Well Name: E W MUDGE	Well Location: T25N / R11W / SEC 16 / NWSE / 36.39909 / -108.00577	County or Parish/State: SAN JUAN / NM
Well Number: 8	Type of Well: CONVENTIONAL GAS WELL	Allottee or Tribe Name:
Lease Number: NMNM036253	Unit or CA Name:	Unit or CA Number:
US Well Number: 3004526217	Well Status: Oil Well Shut In	Operator: DJR OPERATING LLC

Notice of Intent

Type of Submission: Notice of Intent	Type of Action: Plug and Abandonment
Date Sundry Submitted: 02/22/2022	Time Sundry Submitted: 11:52
Date proposed operation will begin: 02/22/2022

**Plug and Abandonment Procedure
for
DJR Operating, LLC
EW Mudge 8
API # 30-045-26217
NW/SE, Unit J, Sec. 16, T25N, R11W
San Juan County, NM**

Proposed Wellbore Diagram
DJR Operating, LLC
EW Mudge 8

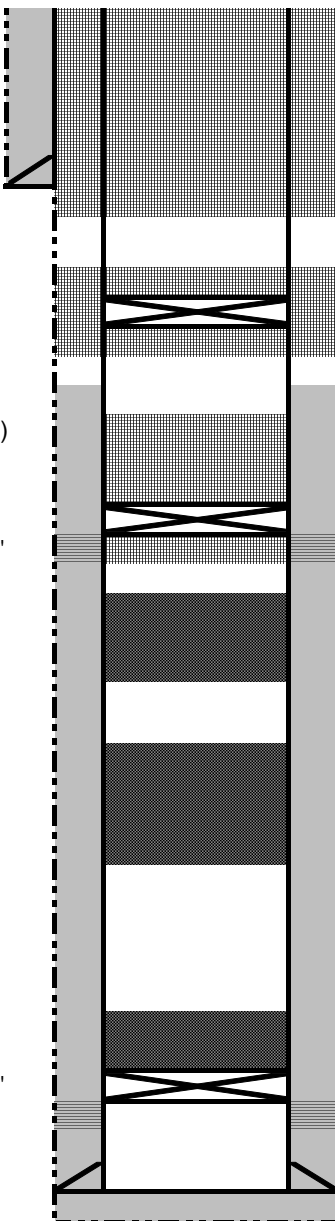
1. Plugging operations authorized are subject to the attached "General Requirements for Permanent Abandonment of Wells on Federal and Indian Lease."
2. Farmington Office is to be notified at least 24 hours before the plugging operations commence at (505) 564-7750.
3. The following modifications to your plugging program are to be made:
 - a. Plug 1: Bring the top to cover the BLM pick for the Fruitland formation top at 1108'.

- BLM pick for the Fruitland formation top vary from Operator's.
- Fruitland/ Pictured Cliffs perfs 4828' – 4988'. No production recorded.
- Plug 1: Bring the top to cover the BLM pick for the Fruitland formation top at 1108'.
